*Please find attached, 2 documents regarding **File: 09426/Z-9427, 517 – 525 Fanshawe Park Road**, which will come before City Council on April 12, 2022.*

Supplemental Report – April 3, 2022, to the Primary Analytical Report March 18, 2022
File: O-9426/Z-9427
517-525 Fanshawe Park Road East

Part of Strik Baldinelli Moniz Preliminary Site Grading Plan SBM-21-0466, Sheet C-4

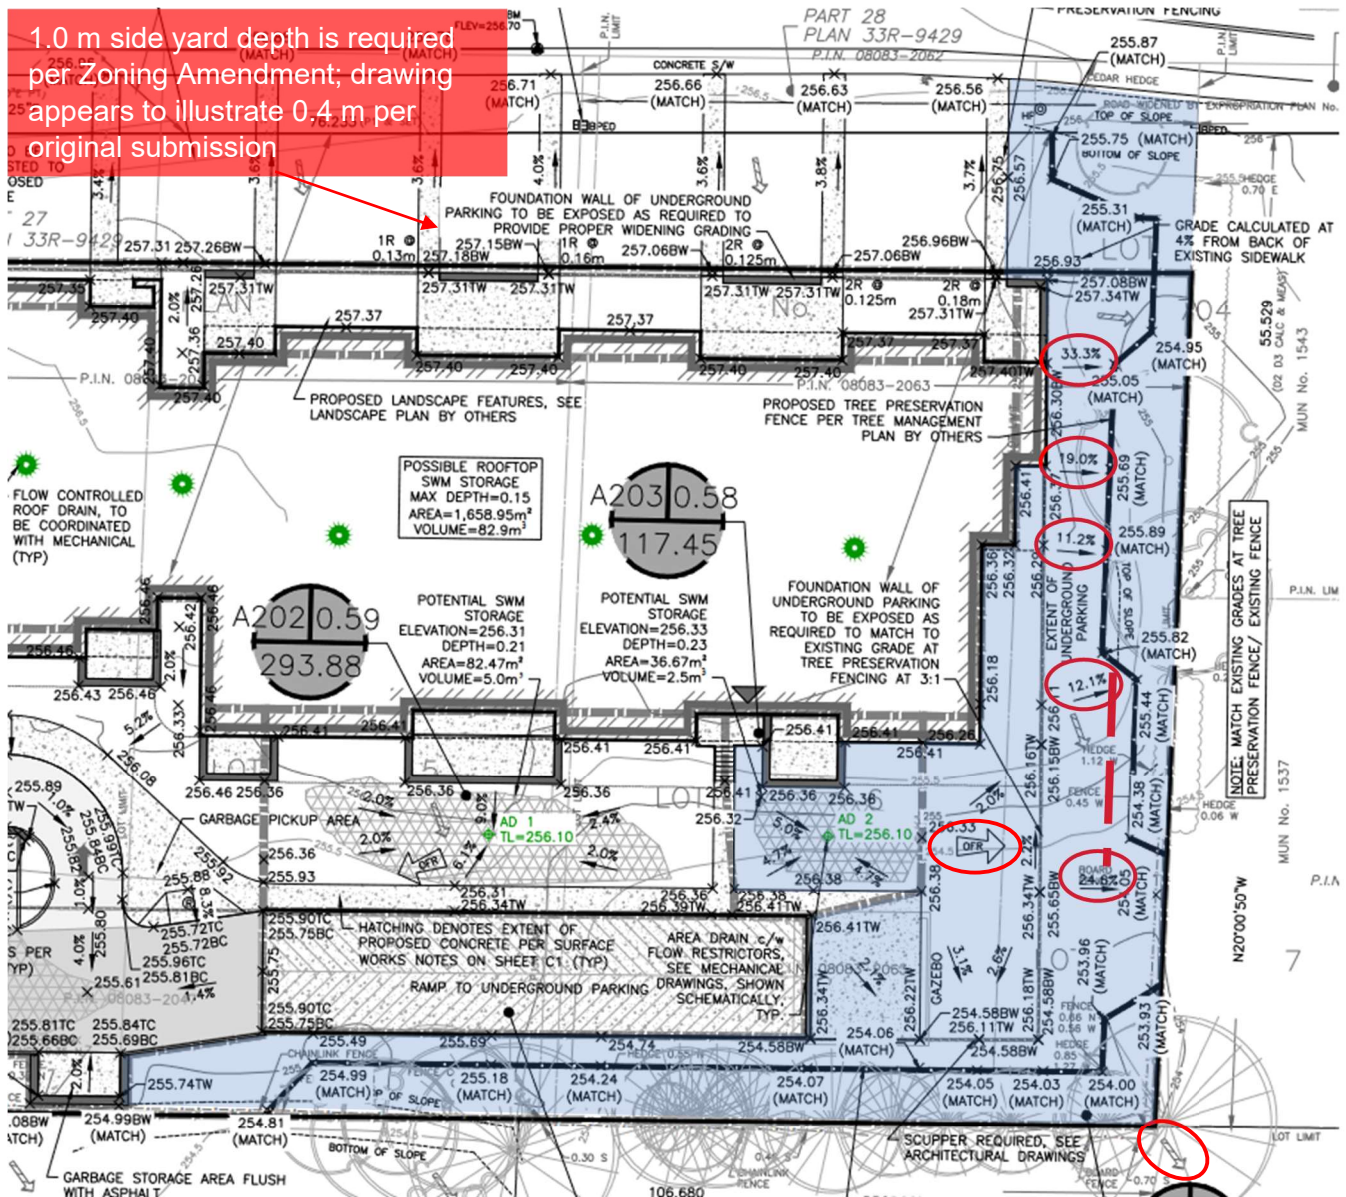
Based on limited information provided on Building Elevation Report drawings by Zedd Architecture, and the Preliminary Site Grading Plan by Strik Baldinelli Moniz consulting engineers, there is an extreme concern with regards to excessive overland stormwater runoff from the rear yard / east yard, and along the interior side yard / south yard of the proposed development. The concentration of the overland flow from these yards to an apparent on-grade outlet in the southeast corner, will be deleterious to neighbouring properties. The gradients along the east side of the building range from 33.3% to 11.2% are extreme and may have deleterious effects on abutting properties. While the area may be small relative to the

overall site, the existing neighbouring yard conditions cannot support the potential volume of stormwater from the concentrated overland flow and the proposed outlet in the southeast corner. With implementation of modern-day stormwater management, combined within an established area with a built environment pre-dating grading plans, alterations of neighbouring properties over the years that may adversely affect the grades, and stormwater runoff patterns, the design of the stormwater management for this proposed development should be to manage all stormwater within the site and through the stormwater sewer system. With consideration of potential climate change and the frequency of 100-year storm events becoming more prevalent, well engineered storm water management is critical. Retaining walls may have to be considered to contour the site inward to retain and manage the stormwater through an engineered restricted out flow or other. Neighbouring properties should not be the dumping ground for this property's stormwater and snow melt. This concern is further addressed / supported by SWED in the Report to the Planning & Environment Committee.
